# 33 Primrose Hill Road (2020/3896/P)

<b>Delegated Report</b>		<b>Analysis sheet</b>	<b>Expiry Date:</b>	<b>04/12/2020</b>
<b>(Members Briefing)</b>		N/A	<b>Consultation Expiry Date:</b>	<b>07/11/2020</b>
<b>Officer</b>			<b>Application Number(s)</b>	
Tony Young			2020/3896/P	
<b>Application Address</b>			<b>Drawing Numbers</b>	
33 Primrose Hill Road London NW3 3DG			Refer to draft decision notice	
<b>PO 3/4</b>	<b>Area Team Signature</b>	<b>C&amp;UD</b>	<b>Authorised Officer Signature</b>	
<b>Proposal(s)</b>				
Installation of air conditioning unit located on flat roof to residential dwelling, including installation of mansafe anchor system fixed to roof and glazed roof hatch to replace skylight.				
<b>Recommendation(s):</b>		Grant planning permission		
<b>Application Type:</b>		Full Planning Permission

*Photos 2 and 3 – showing aerial view of roof area and street facing (front) elevation of building*

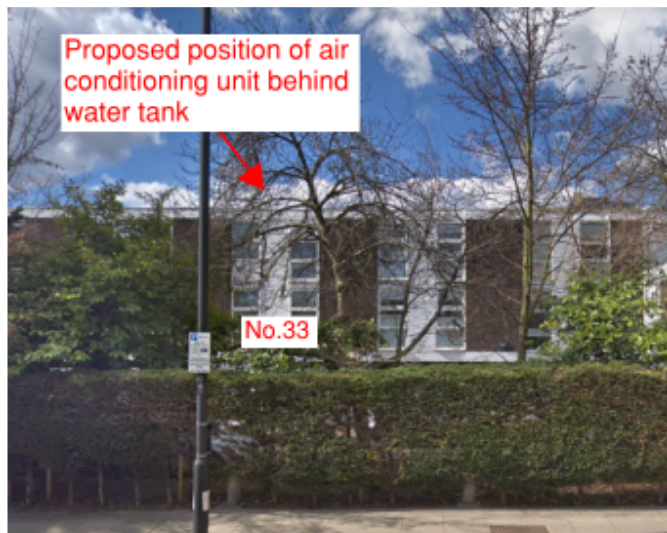
3.3 The building's 3-storey height and set-back position from the street, behind and below the height of a row of mature trees on the west side of Primrose Hill Road, ensure that the property is not visible from the public realm during seasons when the trees are in full leaf. Outside of these times (and as shown on Photo 2 below) the property remains partially screened by trees and it is noted that an existing water tank located on the flat roof is not visible except from long views.

*Photos 1 and 2 – showing aerial view of roof area and street facing (front) elevation of building*

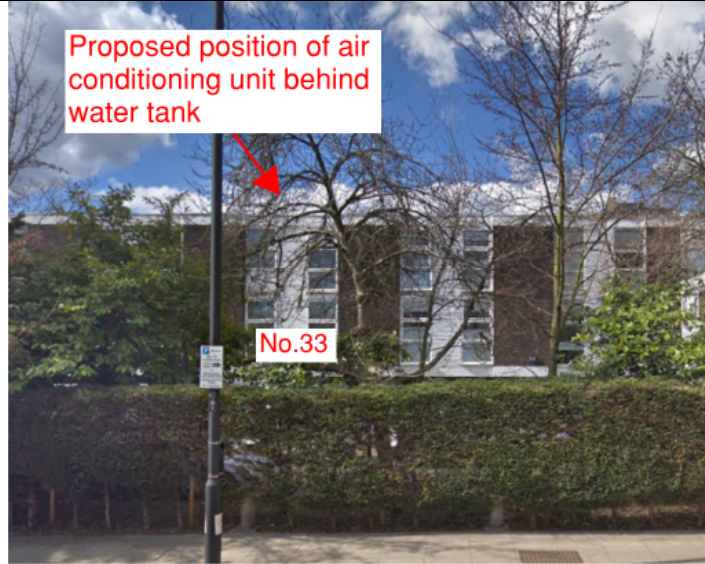
- 3.4 The proposed air conditioning unit is a typical compact outdoor unit (measuring 700mm high x 900mm wide x 330mm deep) and would be mounted on anti-vibration brackets fixed to an existing water tank. As such, the unit would be located in the centre of the roof, behind and below the water tank structure, and would not be visible at the front of the property.

- 3.5 The unit would be set-back from the rear roof edge of the property by approximately 4m (and from the sides by approximately 2m), and as such, would not be visible from rear private gardens or local views. The unit would be visible to some degree in longer views; however, it would appear hardly noticeable given its diminutive size in these views and its centred position relative to an existing water tank which ensures that the proposed unit would blend in closely with this backdrop.
